Mr Ray Fung, Director Engineering and Transportation  
District of West Vancouver,  
750 17<sup>th</sup> Street  
West Vancouver  
V7V 3T3 BC

June 13, 2019

### **Re: Proposed changes to Spirit Trail Multi Use Path & Welch Street Roadway**

### Attachment 3 - "Bend-out" & "Bend-in" Intersection Configurations

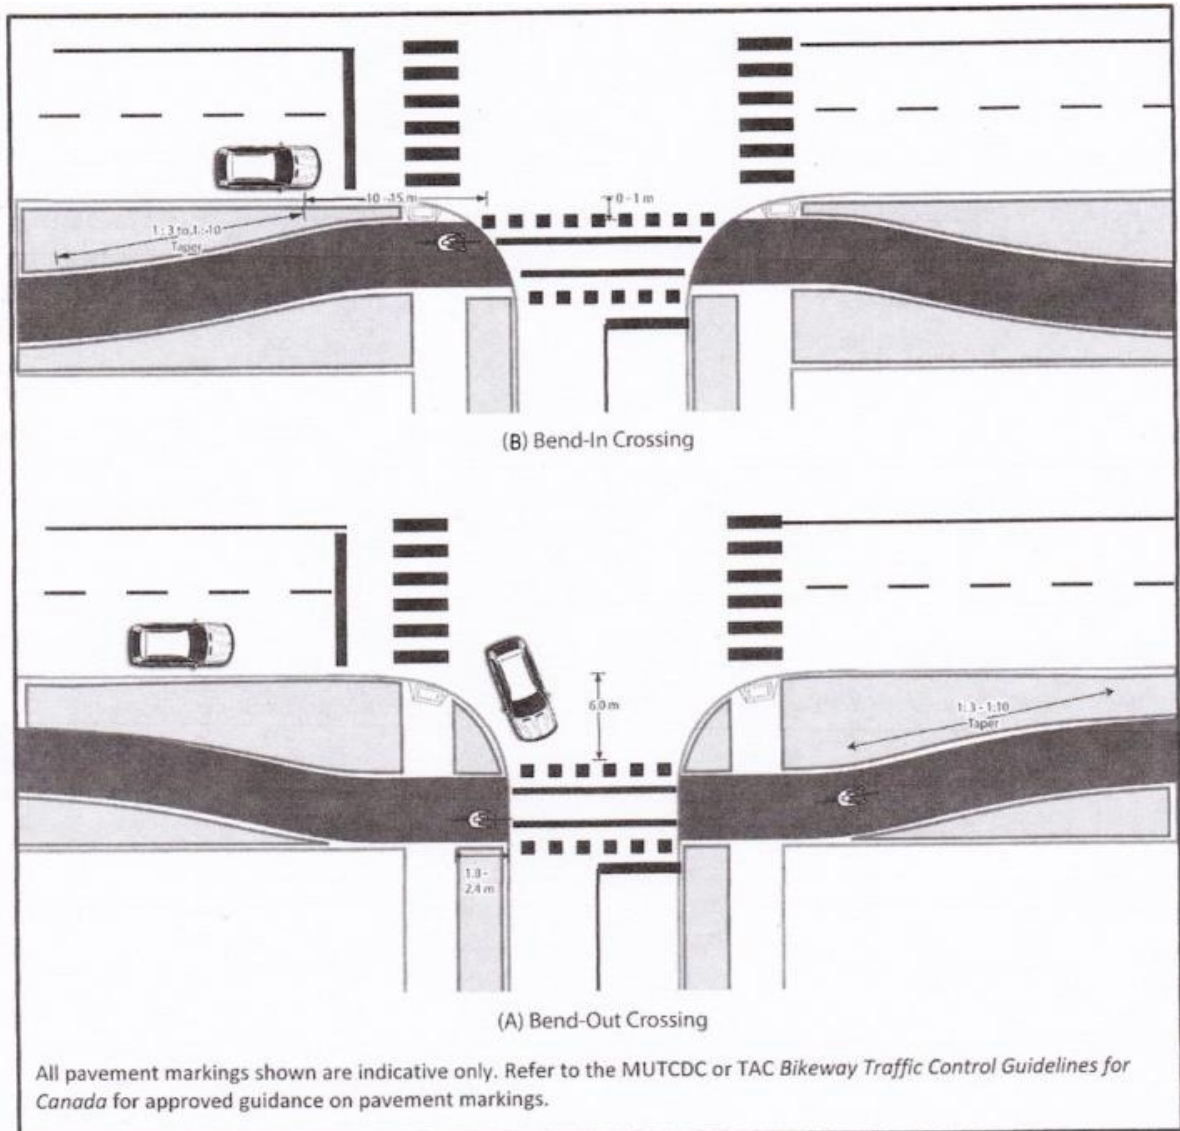
(b) In locations without sufficient motor vehicle refuge space, build “bend-outs” or “bend-ins” to the Spirit Trail where space permits (See Attachment 3). The bend-out/in configurations would cause people cycling to slow down on the approach to the cross street. This type of design should be achievable without damaging the existing trees and foliage, depending on the type.

(i) Bend-outs would create setbacks from Welch for motor vehicles to act as a refuge or queuing area (See Attachment 3, Figure A). Signage explaining where motor vehicles should be positioned in the refuge area would be helpful when exiting the cross streets.

(ii) Bend-ins, such as may be feasible at Ikwikws St, would reduce the two stage crossing to one (See Attachment 3, Figure B).
